ADDENDUM

Project: Davis 2, 3, Ashley Creek Doors

Addendum No.: 1

Date: June 12, 2018

(B) JAMB DETAIL
1 1/2" = 1'-0"

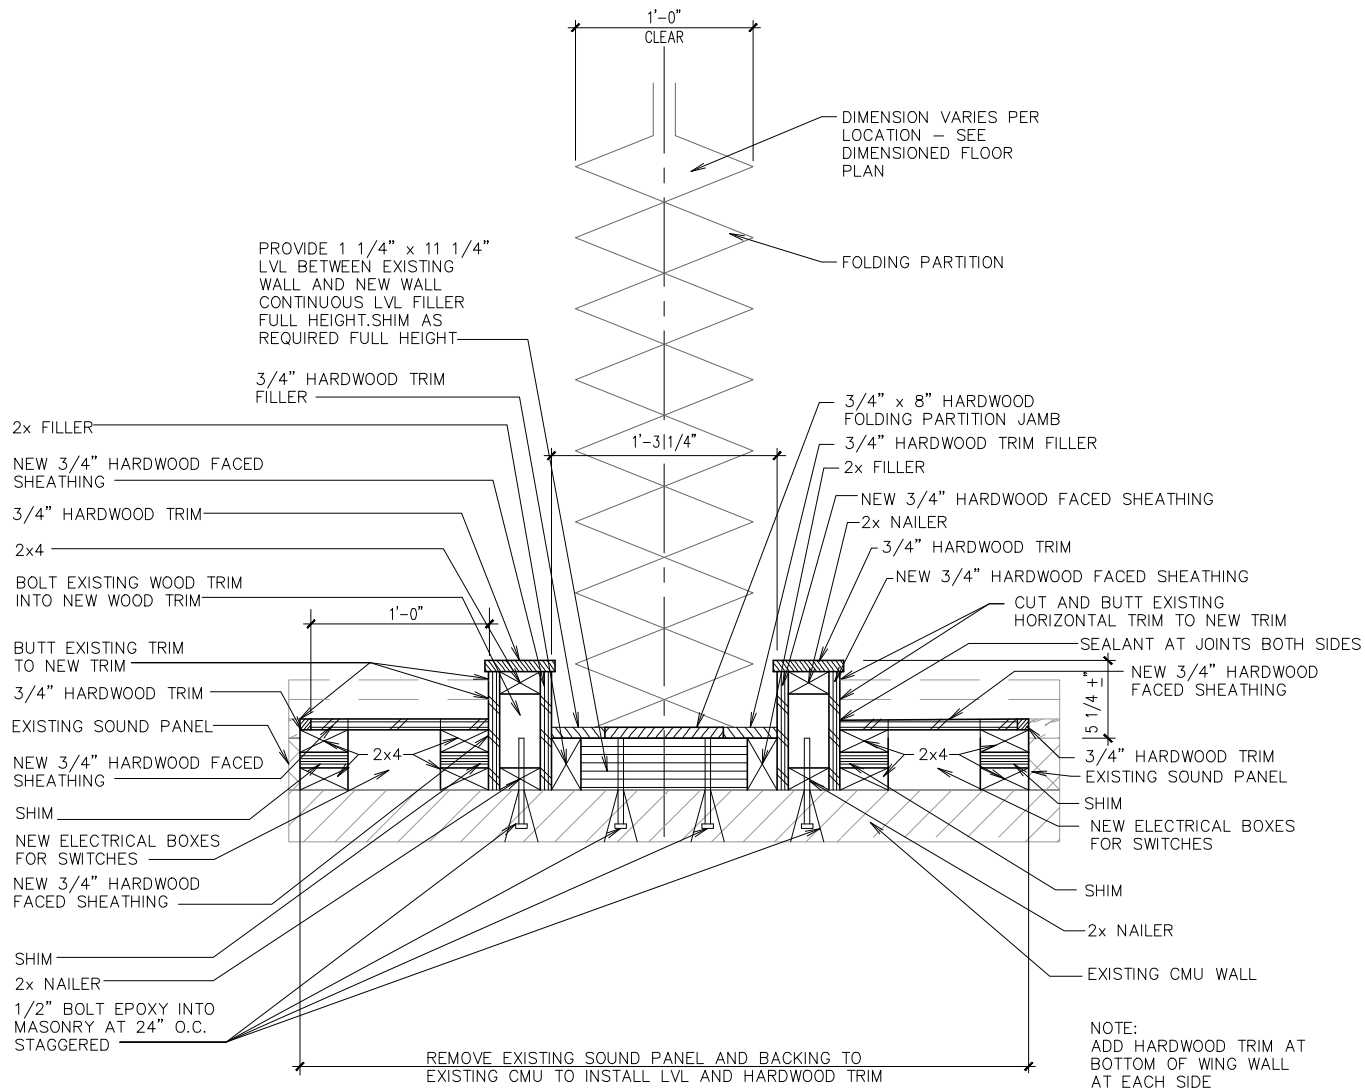
- b. Refer to Sheet **A1.2**.
 - 1) Refer to detail B and replace with the Attached Detail B on Addendum Drawing No. 1.
 - c. Add the following attached Electrical Sheets: EE100 Symbol List General Notes, ED101 Demo Plan – Electrical, EL 101 New Lighting Plan Electrical. Note the deductive alternate on Reference note 2 on Sheet EL 101. Include this amount somewhere on the Bid Form.

Sheet Title:
**DEMO PLAN -
 ELECTRICAL**

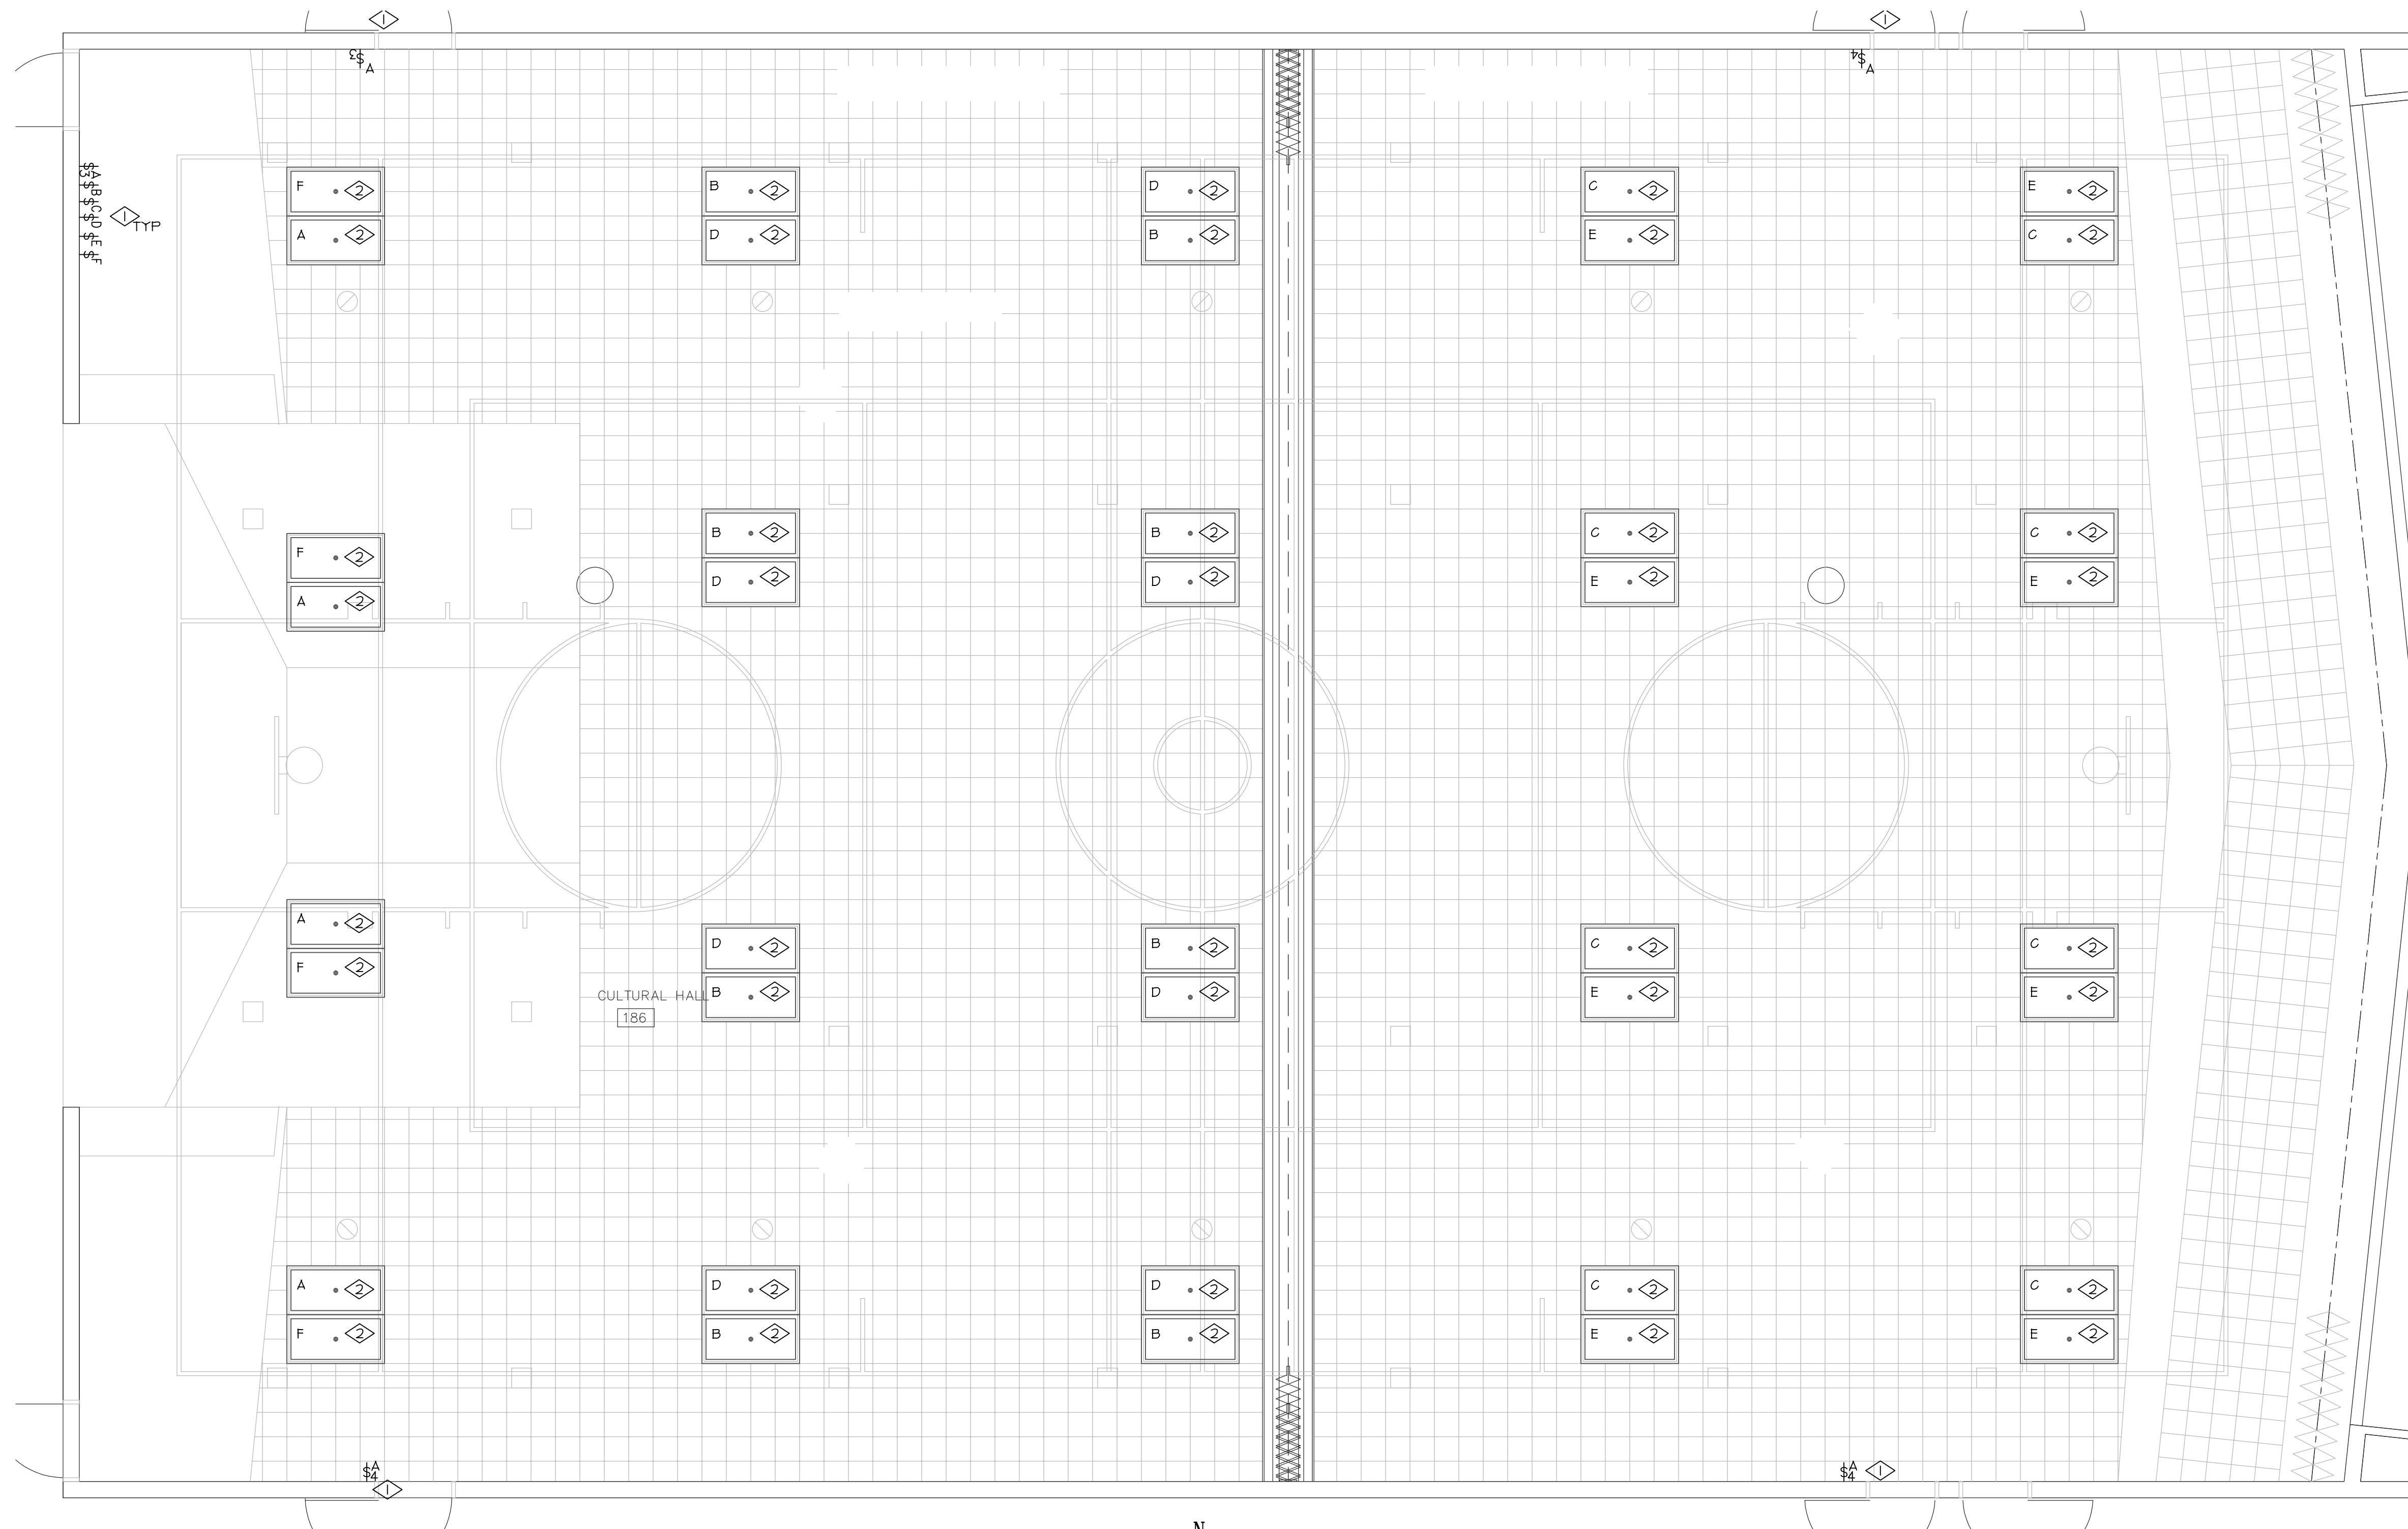
- ① EXISTING LIGHT SWITCHES SHALL REMAIN, MODIFY LIGHTING CIRCUITS AND SWITCHING PER NEW PLANS.
- ② EACH 2X4 LIGHT THAT IN EACH LOCATION, ARE EQUIPPED WITH FOUR FLUORESCENT LAMPS (EACH CLUSTER CONTAINS TWO (2) 2X4 LIGHT FIXTURES), EACH 2X4 IN THE CLUSTER ARE SWITCHED SEPARATELY AS SHOWN AND TIED TO THE ASSIGNED SINGLE POLES, 3-WAYS AND 4-WAYS LIGHT SWITCHES AS SHOWN. CONTRACTOR SHALL FIELD VERIFY EXACT SWITCH LOCATIONS DURING THIS RENOVATION THAT WHICH SWITCHES ARE 3-WAYS AND 4-WAYS. DURING THIS RENOVATION IT IS REQUIRE TO SEPARATE LIGHTING CONTROL OF EACH SIDE OF THE NEW PARTITION TO BE OPERATED INDEPENDENT OF THE OTHER SIDE.
